TOWNSHIP 25 SOUTH, RANGE 7 WEST, OF THE WILLAMETTE MERIDIAN, OREGON

DEPENDENT RESURVEY AND SUBDIVISION OF SECTIONS 13 AND 14

Subject: Correction to official plat, Group 1905, T. 25 S., R. 7 W., Willamette Meridian, Oregon

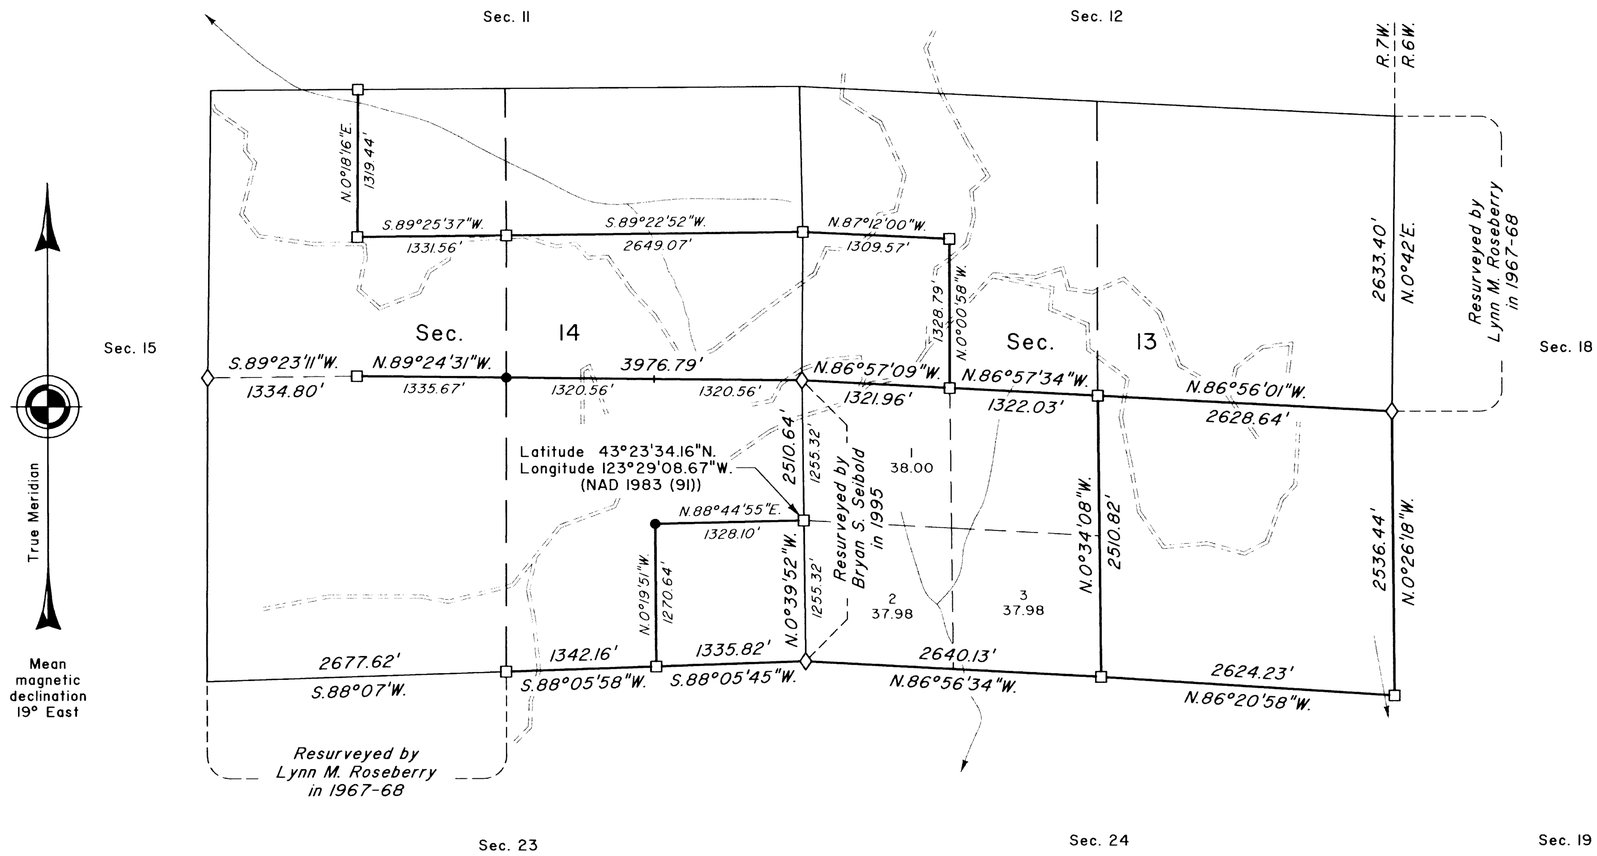
"See amended plat of survey accepted Sept. 4, 2009, for the correct bearing of the east and west center line of Section 14. see Memorandum dated July 13, 2009, File 9632 (0R957000)."

Staff working on the Geographic Coordinate Data Base (GCDB) have discovered that a portion of the bearing of the east and west center line of section 14, is erroneously reported on the plat and field notes accepted August 15, 2001. The correct bearing for the plat and field notes of the line from the ¼ section corner of sections 13 and 14, to the center W 1/16 section corner of section 14, is S. 89° 24' 31" W. (not N. 89° 24' 31" W.).

Therefore, you are hereby authorized to prepare amended plat and field notes. The plat will contain a statement explaining the reason for the amendment to the official record.

Upon acceptance of the amended plat, you are to have placed on the plat of survey for Group Number 1905, accepted August 15, 2001, the following:

> "See amended plat of survey accepted (Date), for the correct bearing of the east and west center line of Section 14, see Memorandum dated July 13, 2009, File 9632 (OR957000)."
